THE MEADOWS OF ISLAND LAKE OF NOVI JSP12-65

Public hearing at the request of Toll Brothers, Inc. for recommendation to City Council for approval to include the subject property in the existing Island Lake of Novi Residential Unit Development (RUD) and modifications to the RUD concept plan. The subject property is 40.68 acres in Section 20 of the City of Novi and located near the northeast corner of Ten Mile Road and Wixom Road. The applicant is proposing a 74 unit development that would be Phase 7 of the existing Island Lake of Novi development. The applicant has also proposed to modify the number of units permitted in the RUD Agreement from 884 to 916 in order to allow for the potential future expansion of the development.

January 31, 2013 **Planning Review** The Meadows of Island Lake Of Novi **JSP12-65**

Revised RUD Amendment, Revised RUD Plan, Revised Preliminary Site Plan and Phasing Plan

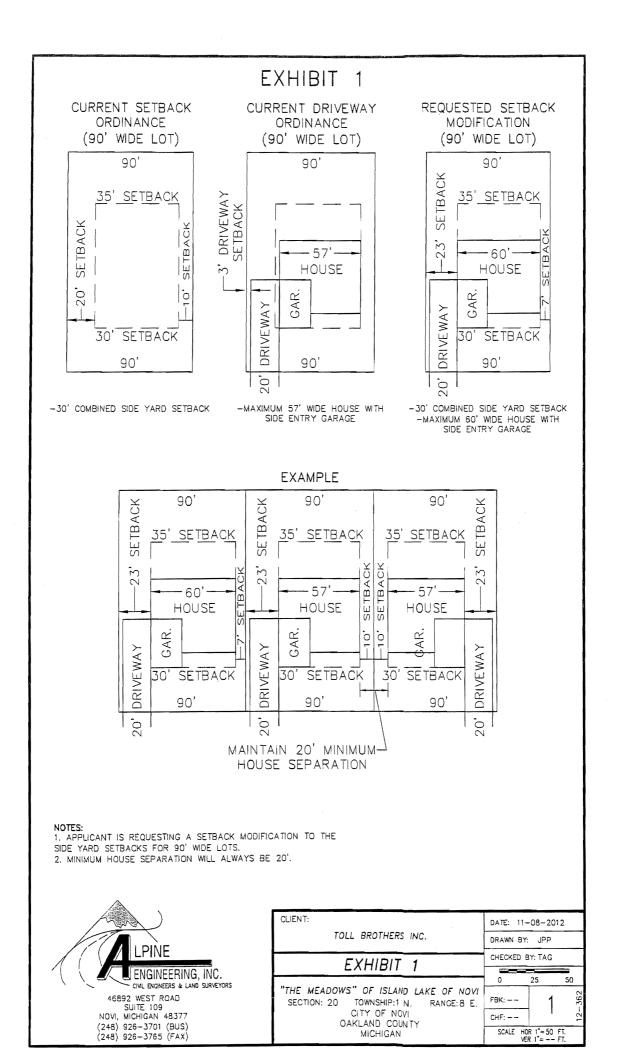
Additionally, applicant requests consideration of a slight modification to the side yard set backs to correct an administrative oversight as described on attached Exhibit 1.

The current RUD setback requirements for 90' minimum wide lots are as follows: Front: 30' Rear: 35' Side-Yard: 10' minimum, 30' total

The requested setback requirements for 90' minimum wide lots are as follows: Front: 30' Rear: 35' *Side-Yard: 7' minimum, 30' total *Maintain 20' minimum between buildings

Justification for reduction in side-yard setback requirement:

The majority of the existing houses within the Island Lake of Novi community have side-entry garages. The applicant believes this was the original intent of the RUD when 30' combined setbacks were originally approved, but other City Ordinance regulating driveways inadvertently modifies this to 33' and contradicts the RUD.
